27 April 2021

Our Ref: 2021/282225

**10 and 12 Boondah Road and 6 Jacksons Road Warriewood
Confirmation of matters regarding the concept masterplan**

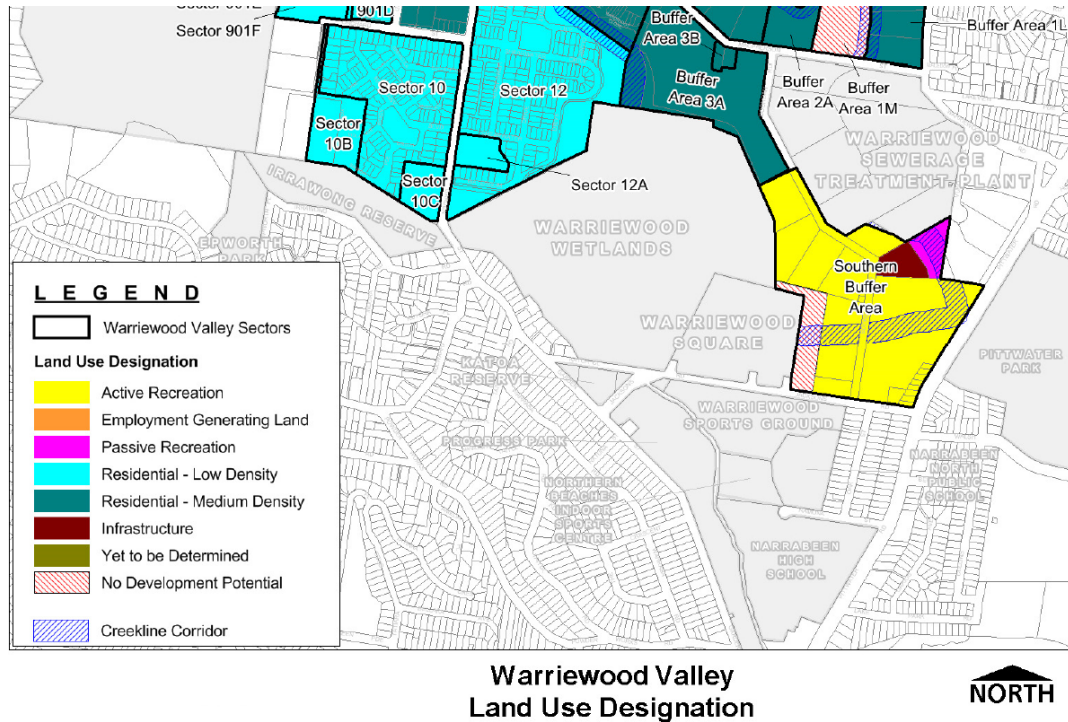
The Warriewood Valley Strategic Review Addendum Report 2018 (the 2018 report) aimed to identify a forward direction for those areas (including the Southern Buffer area and the subject sites) not rezoned following on from the 2012 report. The 2018 report, having been informed by the Narrabeen Lagoon Flood Study 2013, identified that floor levels for development would increase, classified the subject

site under Category F classification, which restricted the recommended land uses to sporting fields and recreational uses. For the subject sites, an extract of the Land Use designation recommended from the 2018 report recommended, is shown below:
